**Arthur Ashe Boulevard**  
**BRIDGE PROJECT**

# June 11, 2025 Community Meeting Comment Summary Report

The City of Richmond hosted a Community Meeting on June 11, 2025, at the Science Museum of Virginia, to share and gain feedback on proposed plans for the Arthur Ashe Boulevard Bridge project.

## N Arthur Ashe Blvd Bridge Delinated

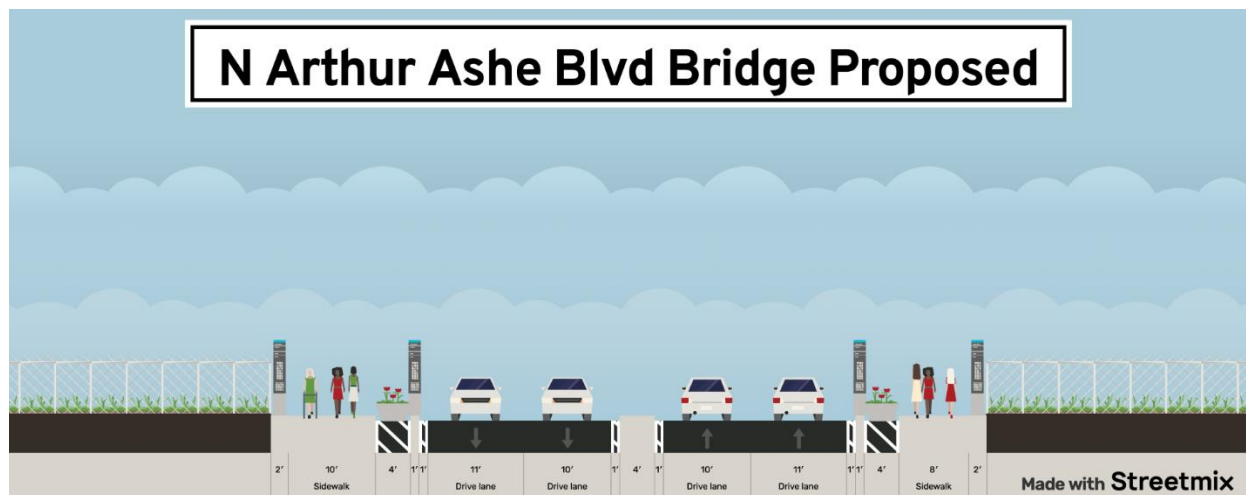
There is room on the current bridge design for delineation between pedestrians and cyclists without sacrificing the current proposed car lane width. See the below images for comparison, and please note I had to get a little creative with what I used in Streetmix.

Concrete delineation isn't difficult to do on shared-use paths and would prevent small children or dogs from easily wandering into the cycle lanes.

Also see the example below of a bridge in the UK which uses small delineators. These are nice because if your bike tires pops you can mode switch to being a pedestrian while on the bridge.
